ORIGINATION FORM

Proposed Revisions to a Standard Plans Index

Index Number: 700-091

Index Title: Catwalk Details

INDEX
700-091

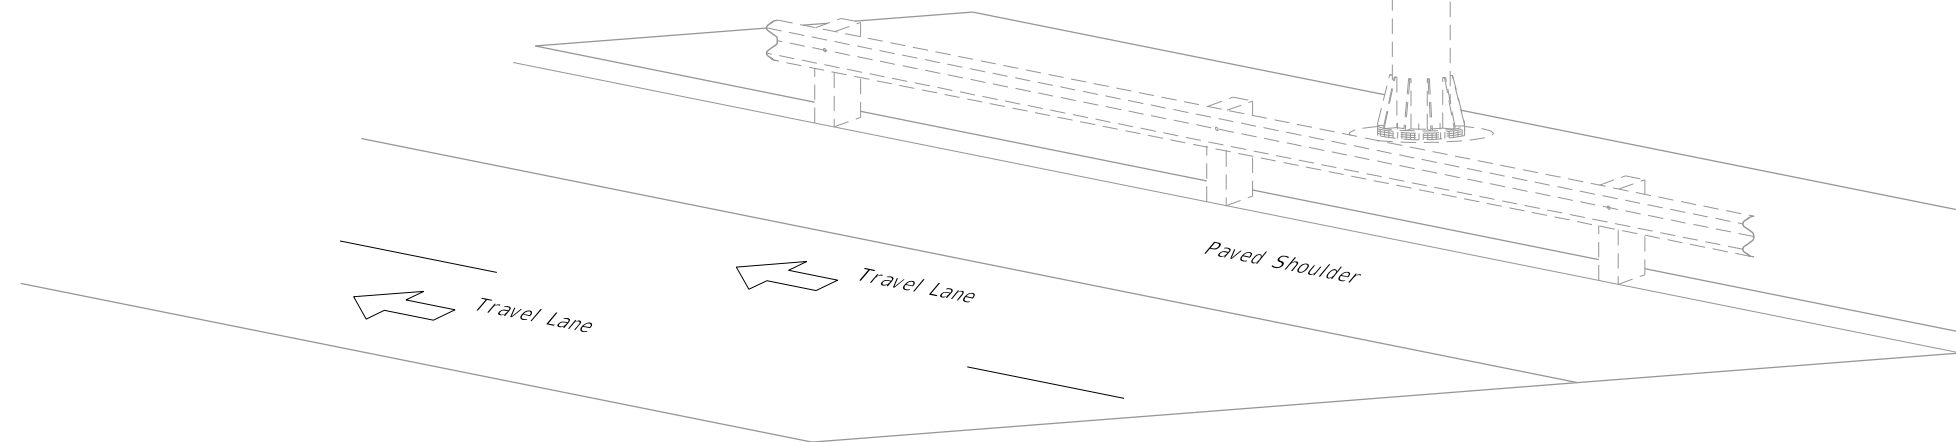
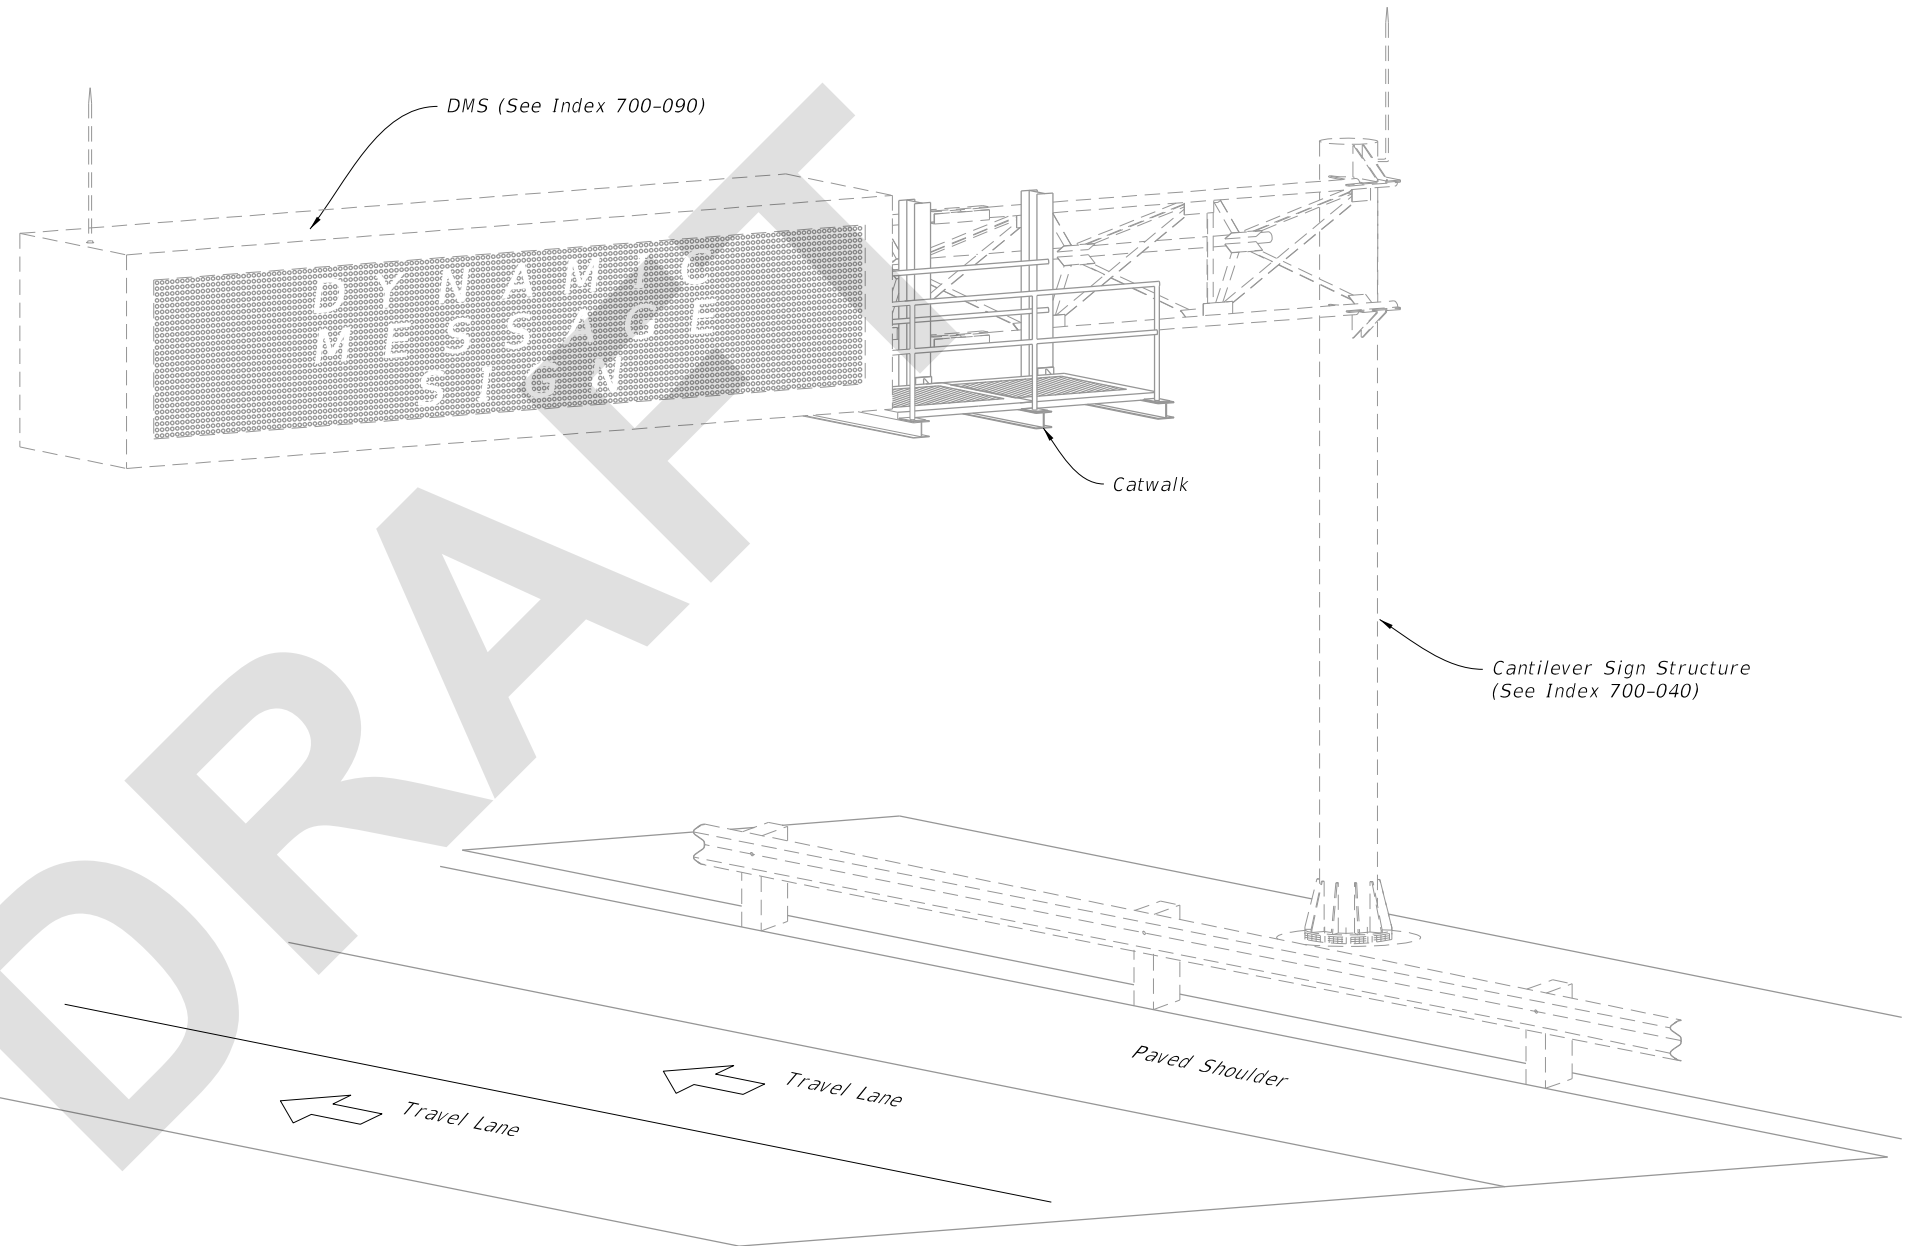
Updated General Note 1 - "Meet the requirements of Specification 700."; Deleted Note 9 through 11; Renumbered General Notes.

UPDATED NOTE: Meet the requirements of Specification 700.

~~9. Welding:~~

~~10. Materials:~~

~~11. Coatings/Galvanizing:~~

DELETED

GENERAL COMMENT: Some material information was deleted. Information is either already covered in Standard Specifications OR will be added to Section 700, 962 or 965 in conjunction with these revisions.

The 700 Index Series is being edited to remove material information and other information that is located in the Standard Specifications. Revisions are being made to Specification Sections 700, 962 and 965 in conjunction with these changes.
